From: [Shawnee Wysong](#)
To: [Sims, April](#)
Cc: [Andrews, Sophia J](#); [Weingart, James](#)
Subject: Re: IN2430163 Steuby's LLC Inspection Summary 06.10.2024
Date: Thursday, June 27, 2024 5:14:03 PM
Attachments: [image001.png](#)
[image003.png](#)
[image004.png](#)
[image005.png](#)
[image006.png](#)
[image007.png](#)
[image008.png](#)
[image009.png](#)
[2092_001.pdf](#)

Attachment 1 below body - Literature from the mfg. showing that the passive water conditioning system is NSF certified.

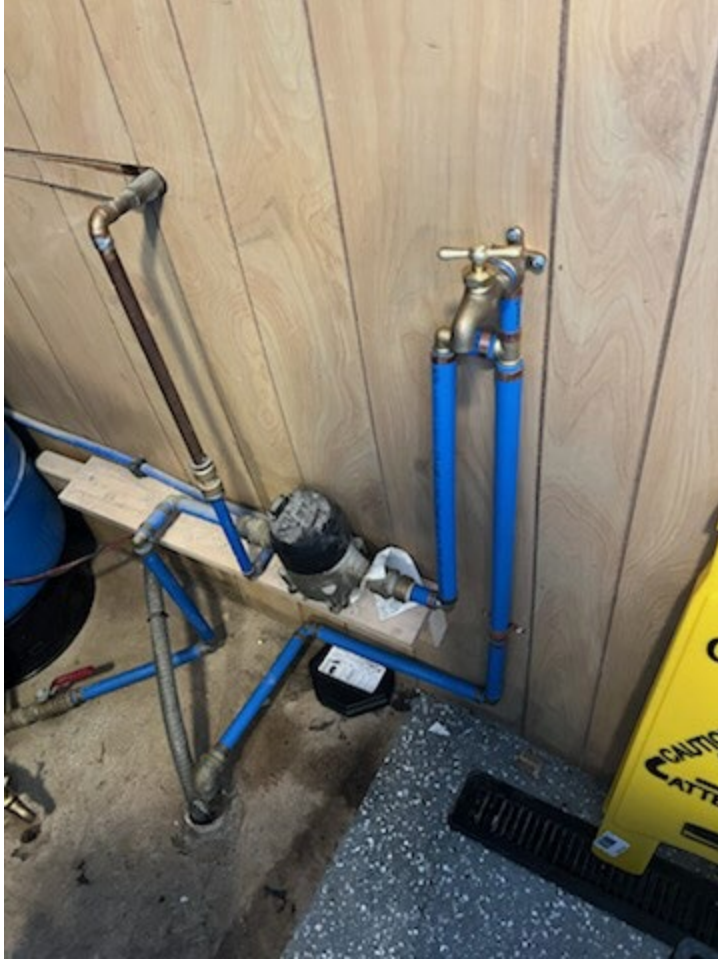
Per our previous phone conversation, it is my understanding that permits were not required due to the type and nature of the conditioning system. Going forward, I understand that I will need to contact IDEM prior to making any modifications.
